**POOR A/C PERFORMANCE DUE TO LEAKING REFRIGERANT
FROM THE AIR CONDITIONER CONDENSER PIPE**

Bulletin No.: 07-003/22

2016-2022 CX-9

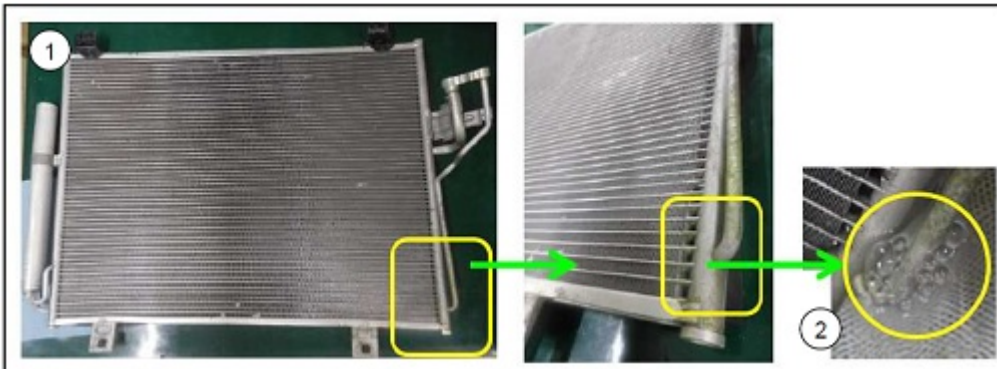
1. Verify the customer concern.
2. Use a gas leak tester or a fluorescent agent-detecting UV black light to check if there is a leak from the condenser (1) from the area shown (2) in the figure.

- If gas leaks from this area, replace the condenser with a modified one.
 - 2016-2020 CX-9 (CONDENSOR REMOVAL/INSTALLATION)
 - 2021-2022 CX-9 (CONDENSOR REMOVAL/INSTALLATION)
 - If there is no gas leak from this area, troubleshoot the poor A/C performance according to the instructions on MGSS.
3. Verify the repair.
